**DEPARTMENT OF TRANSPORTATION  
STATE OF GEORGIA**

**FILE:** STP-0004-00(915), Bartow/Floyd  
STP-19-1(15) & BHF-019-1(16) Bartow  
P. I. Nos.: 0004915, 621500, & 621505  
S.R. 140 Widening/Reconstruction

**SUBJECT: IMPLEMENTATION OF VALUE ENGINEERING STUDY ALTERNATIVES**

**SUBJECT** Value Engineering Study - Responses

Subject SR140 over CSX RR - Bartow County  
PI#621505 MSE Wall Cost Analysis

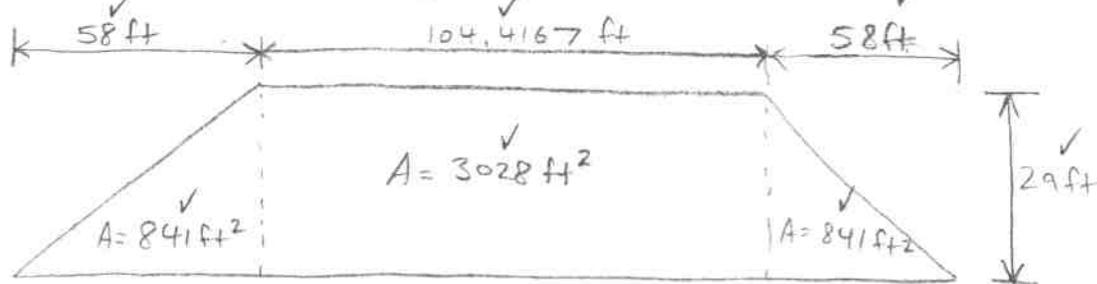
Avg Grade El @ Bents 2 & 3 :  $\frac{728.39 + 727.01}{2} = 727.7$

Super Str. Depth = 4 ft

Cap Depth = 2 ft

Top of Wall  $\approx 727.7 - 6\text{ft} = 721.7$

Base of Wall =  $695 - 2\text{ft} = 693$

Wall Ht =  $721.7 - 693 = 28.7\text{ft} \approx 29\text{ft}$

Total Wall Area =  $4710 \times \$35 \text{ per sf} \times 2 \text{ walls} = \boxed{\$329,700}$   
Wall Cost

(can shorten approx 55 ft from each end, 110 ft total)

$(104.4167)(110\text{ft})(\$95 \text{ per sf}) = \boxed{\$1,091,155}$   
Bridge Savings

Total Savings =  $\$1,091,155 - \$329,700 = \boxed{\$761,455}$   
Total Savings
